ARKANSAS POWER & LIGHT COMPANY

ARKANSAS NUCLEAR ONE, UNIT 2

AMENDMENT TO FACILITY OPERATING LICENSE

Amendment No. 33
License No. NPF-6

FIGURE 3.3-1

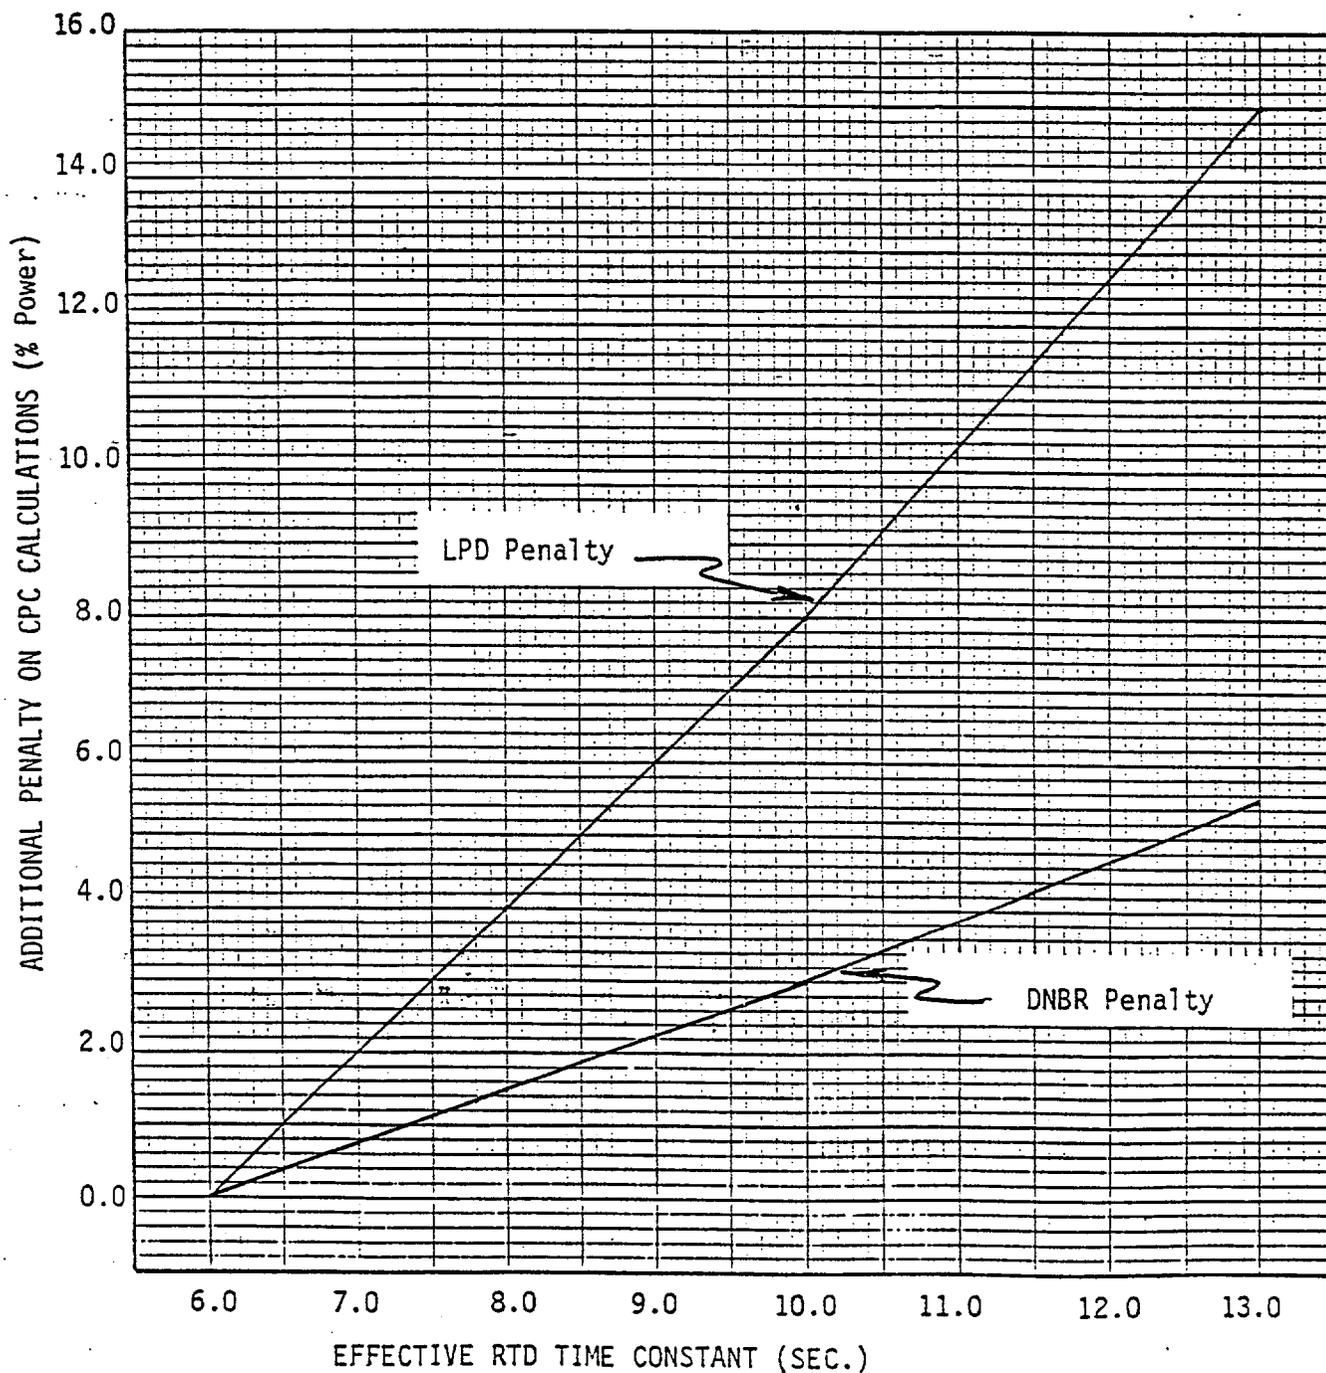
If the effective RTD time constant for a CPC channel exceeds 6.0 seconds, the DNBR and LPD penalties for the affected channel(s) shall be increased by the amount indicated on Figure 3.3-1, and the Power Operating Limit on DNB will be decreased by the amount shown in Table 3.3-3.

The impact on the power used in the determination of LPD by CPC was evaluated with the single CEA withdrawal event. The results indicate that the LPD penalty should be increased by 4%, 10% and 15% for RTD response times of 8, 10 and 13 seconds, respectively. This penalty factor is shown in Figure 3.3-1 of the revised TS and will be applied to the CPC addressable constant BERR4, which is the uncertainty bias factor on power used in the local power density algorithm. This is found acceptable.

The staff has reviewed the proposed Technical Specification change to allow continuing plant operation with effective RTD time constant exceeding 6 seconds. The penalty factors associated with the degraded RTD response time shown in Figure 3.3-1 and Table 3.3-3 of the revised TS are acceptable for applying to the CPC addressable constant BERR0, BERR2 for DNBR calculation, and BERR4 for LPD calculation and POL for the COLSS trip setpoint.
